Product Change Notice (PCN)

PCN Number: PCN-0485225R-01

Product(s) Affected: *CPM1211 Series (CPM1211-02A-01-FRA-P7-67, CPM1211-03A-01-FRA-P7-67, CPM1211-04A-01-FRA-P7-67, CPM1211-05A-01-FRA-P7-67, CPM1211-08A-01-FRA-P7-67, CPM1211-02A-01-FRA-P9-67, CPM1211-03A-01-FRA-P9-67, CPM1211-04A-01-FRA-P9-67, CPM1211-05A-01-FRA-P9-67, CPM1211-08A-01-FRA-P9-67)*

PREVIOUS SAME SKY DETAIL / IMAGE		NEW SAME SKY DETAIL / IMAGE

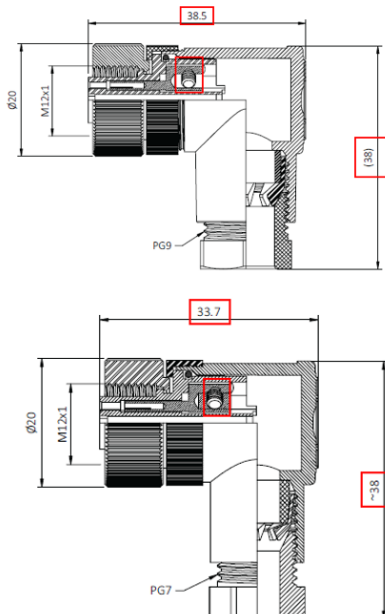
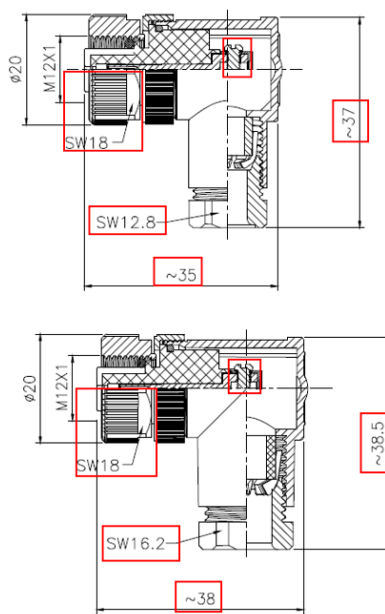
Visual differences

- Previously flat surface area is now rounded, marked SW18
- Screw terminal was previously a Philips and is now a Slot head
